## IN THE UNITED STATES PATENT AND TRADEMARK OFFICE

Applicant: Dardo Bonaparte Lujan  
Serial Number: 10/791,054  
Filing Date: March 2, 2004  
Title: Armored Assembly  
Examiner: Troy Chambers  
Art Unit: 3641

**RESPONSE TO OFFICE ACTION**

Fig. 16

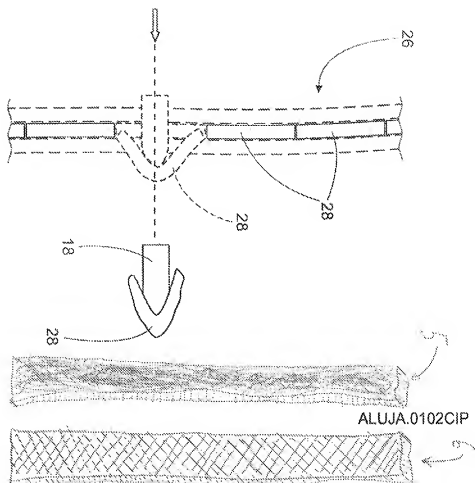
The attached sheet of drawings includes changes to Fig. 16. This sheet, which includes Fig. 15-16, replaces the original sheet including Fig. 15-16. In Fig. 16, elements 5 and 6 from Fig. 1 have been added to Fig. 16.

In the Office Action, the Examiner has again objected to the drawings under 37 CFR §1.83(a) in that the drawings are deemed not to show every feature of the invention. Specifically, the Examiner contends that the “at least one projectile stopping panel” (Claims 15, 16), “the impact cushioning panel” (Claim 28), and “the projectile stopping panel comprising loosely-entangled fibers” (Claim 29) are not shown in the drawings. In the previous Office Action, Applicant pointed out to Examiner that these features were already shown in FIGS. 1 and 9. During an informal telephone conversation with Examiner on August 8, 2006, Examiner noted that these features are not shown in FIGS. 15 and 16, which represent specie E elected with traverse by Applicant pursuant to a restriction requirement. Examiner also stated that he would not look outside FIGS. 15 and 16 for the above referenced features.

Pursuant to Examiner’s suggestion that he will not look at any other figures other than FIGS. 15 and 16 for the features of the invention, replacement drawing sheets are attached to this response clearly depicting the “at least one projectile stopping panel” (Claims 15, 16), “the impact cushioning panel” (Claim 28), and “the projectile stopping panel comprising loosely-entangled fibers (Claim 29) in FIG. 16. Specifically, the “at least one projectile stopping panel” and “the projectile stopping panel comprising loosely entangled fibers” are identified by reference numeral 5. The “impact cushioning panel” is identified by reference numeral 6.

Paragraph 0042 of the published application refers in the description of FIG. 1 to “at least one projectile-trapping panel 5.” Likewise, the specification at paragraph 0070 refers to “at least one projectile-stopping panel, or trapping panel”, which indicates that the terms “projectile trapping panel” and “projectile stopping panel” are used interchangeably. Such panel is now clearly depicted in FIG. 16 and identified by the reference numeral 5.

The “projectile stopping panel comprising loosely entangled fibers” in claim 29 is also shown in FIG. 16. Applicant respectfully refers Examiner to the preceding paragraph indicating that the terms “projectile stopping panel” and “projectile trapping panel” are used interchangeably. To the extent Examiner believes that the “loosely entangled fibers” portion of claim 29 is not shown, Applicant refers Examiner to paragraph 0055 of the specification, wherein it is disclosed that “the projectile-trapping panels 5 ... may comprise a mass of loosely-entangled microfibers 15, FIGS. 1 and 2.” The same paragraph goes on to state that “the term ‘microfiber’ must be understood as encircling all kind of fibers, filaments, threads and the like.” The term “loosely entangled” is defined in paragraph 0057 of the specification. The term “loosely entangled” is also described and claimed in U.S. Patent No. 6,684,468, col. 4, l. 45 through col. 5, l. 12 and claim 1. Therefore, “the projectile stopping panel comprising loosely entangled fibers” in claim 29 is now depicted in FIG. 16 and identified by reference numeral 5.

Applicant also respectfully submits that the “impact cushioning panel” referred to in claim 28 is now shown in FIG. 16. In paragraph 0043 the specification discloses “at least one impact cushioning panel 6, see FIG. 1”. Again, Applicant respectfully refers Examiner to the description of FIG. 16, paragraph 0069, which also refers to FIG. 1 and incorporates the ballistic panels of FIG. 1 by reference into the description of FIG. 16. Because the “impact cushioning panel”, “the projectile stopping panel”, and “the projectile stopping panel comprising loosely entangled fibers” originally shown in FIG. 1 are now shown in FIG. 16 and identified by the reference numerals 5 and 6, Applicant requests that Examiner withdraws his objection under 37 C.F.R. 1.83(a) that these features are not shown in the drawings.
